**Lockport-Batavia Line #112
Rebuild Project**

Agency Correspondence

Re: USACE
National Grid - Lockport Batavia #112 Transmission Line Rebuild & Structure
Replacement Project
Royalton & Lockport Niagara County and, Alabama, Genesee County, NY
21PR00596

**Re: National Grid – Lockport Batavia #112 Project
20PR00596
Response to SHPO Comments**

Map

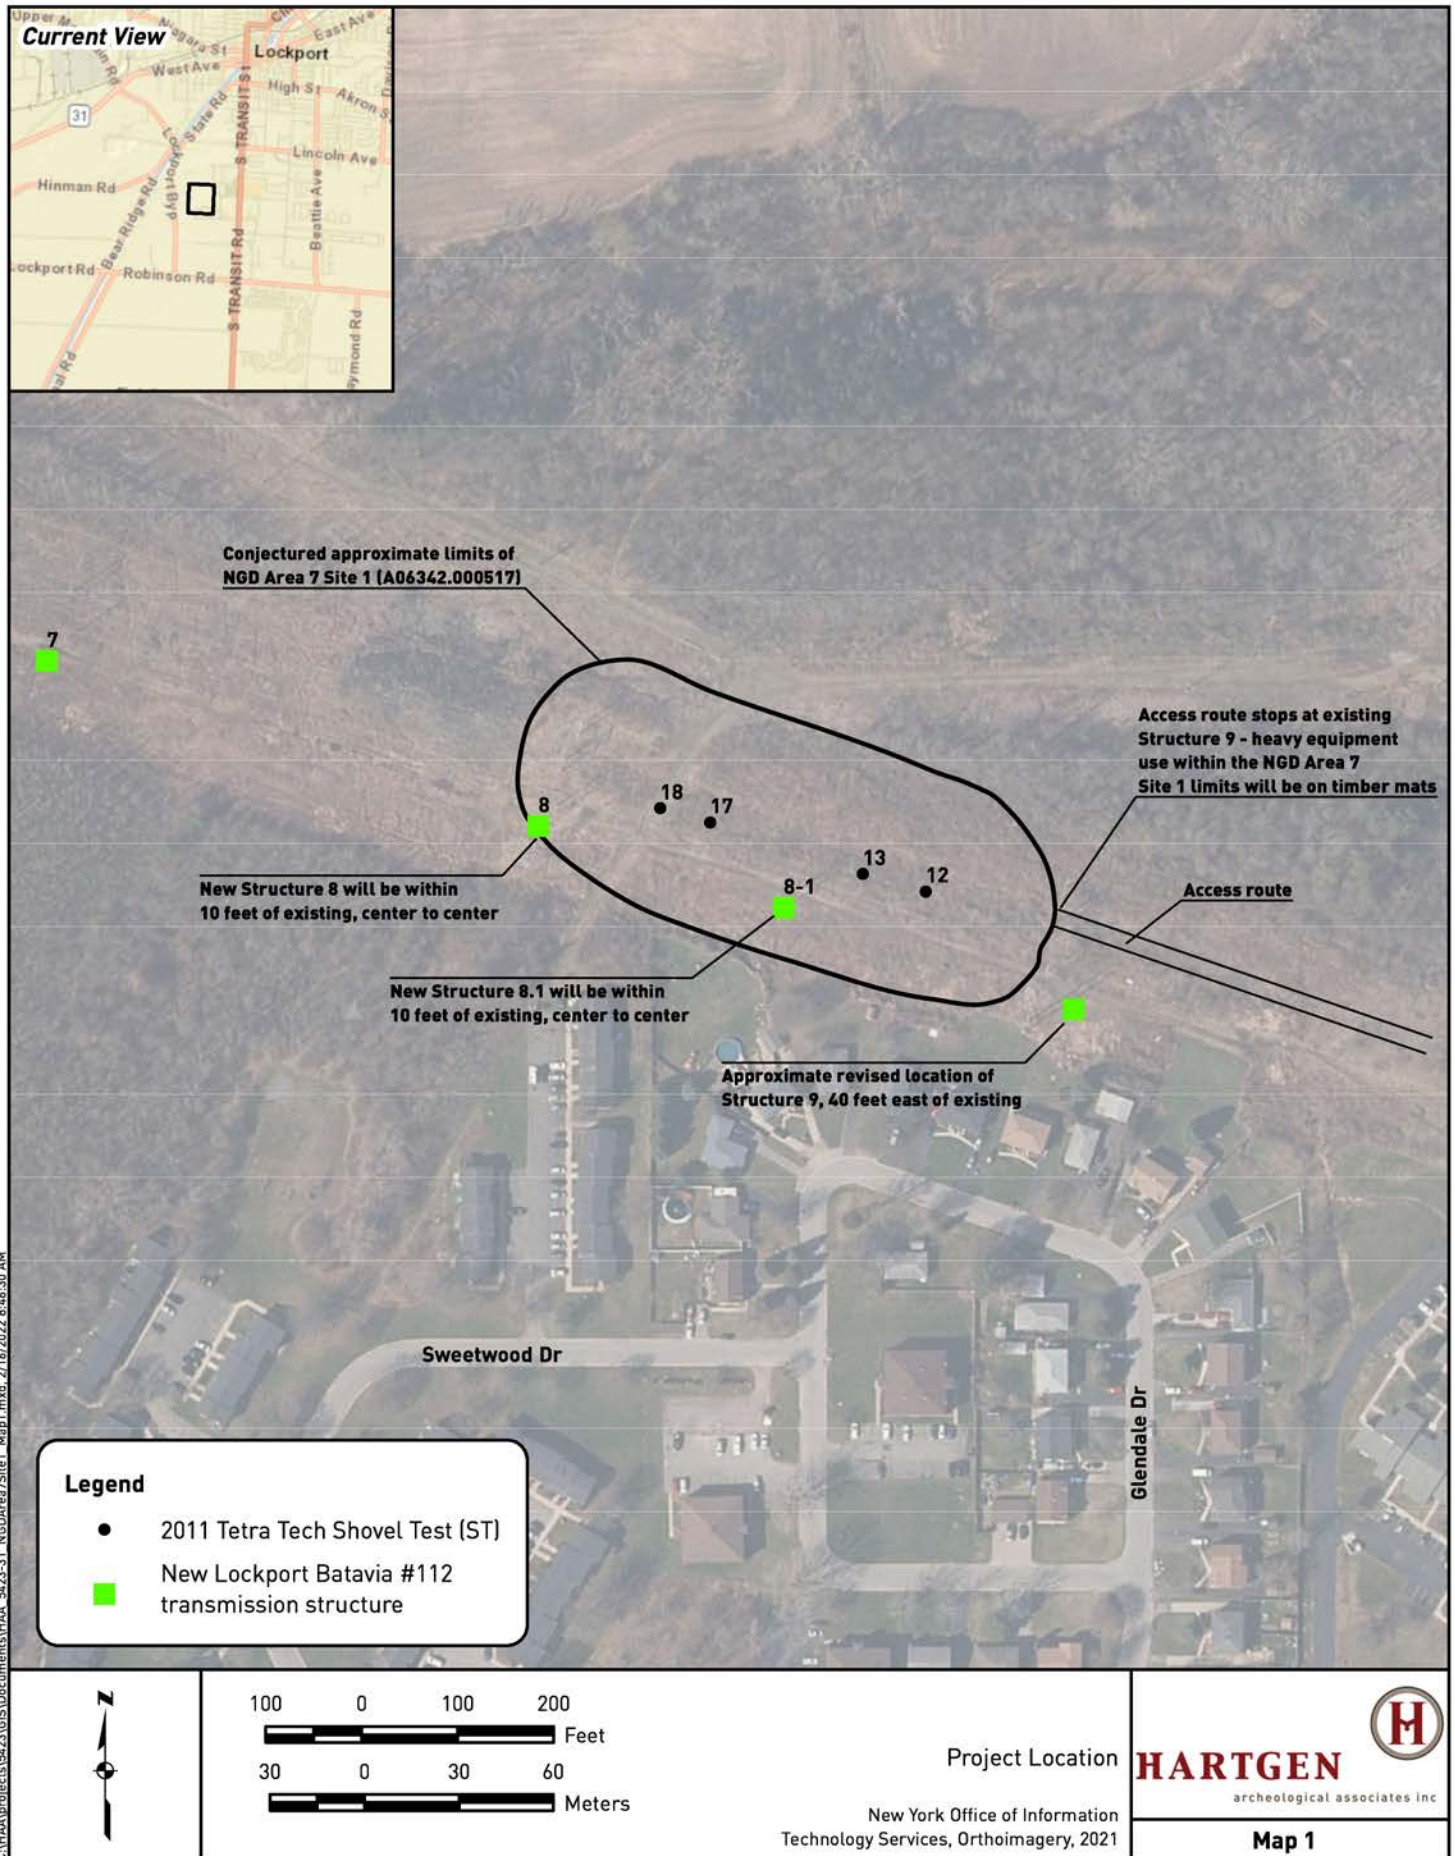
OPRHP is in receipt of the Site Avoidance Map for NGD Area 7 Site 1 (USN 06342.000517) submitted to our office on March 8, 2022. Based upon our review of this map, we can confirm that the proposed Access Route has been revised and now terminates outside of the site and its corresponding fifty-foot (50-ft) buffer zone. It was OPRHP's understanding, however, that the site and its buffer zone would be avoided entirely. Nonetheless, New Structures 8, and 8-1 are within the site's boundary area, and along with New Structure 9, are in areas not previously covered by an archaeological survey, and thus we cannot confirm that the site does not extend out to these impact areas. When there is a known cultural resource/archaeological site within the project's Area of Potential Effects (APE), the guidance suggesting the locations of new structures within 10-feet of an existing structure do not need to be surveyed is not applicable. Avoidance areas are to be avoided wholly. OPRHP thus continues to recommend that the site, including its 50-ft buffer zone, be avoided, that temporary fencing around the site is erected prior to and throughout construction, and "ENVIRONMENTALLY SENSITIVE – NO ACCESS" signage be affixed to the fence, and be similarly indicated on construction drawings/site plan maps. The fencing can be removed upon completion of construction. If Site avoidance is not feasible, then OPRHP recommends addendum Phase IB testing in all areas of proposed ground disturbance associated with the erection of new towers 8, 8.1, and 9.

Please indicate if the intent is to entirely avoid the NGD Area 7 Site 1 and its buffer zone, or conduct additional Ph. IB testing in the noted areas. If site avoidance is chosen, please submit updated site avoidance plans. If additional Ph. IB testing will be conducted, I will need to provide you with a new CRIS survey token for the addendum report.

Thank you for your email and inquiry. As per my letter of March 11, 2022 (see attached), in response to the submission of the "avoidance plan" for NGD Area 7 Site 1 (USN 06342.000517), the plan does not satisfactorily avoid impacts to the site. It was OPRHP's understanding and expectation, that the site and its buffer zone would be avoided entirely. New Structures 8, and 8-1 are

within the site's boundary area, and along with New Structure 9, are in areas not previously covered by an archaeological survey, and thus we cannot confirm that the site does not extend out to these impact areas. When there is a known cultural resource/archaeological site within the project's Area of Potential Effects (APE), the guidance suggesting the locations of new structures within 10-feet of an existing structure do not need to be surveyed is not applicable.
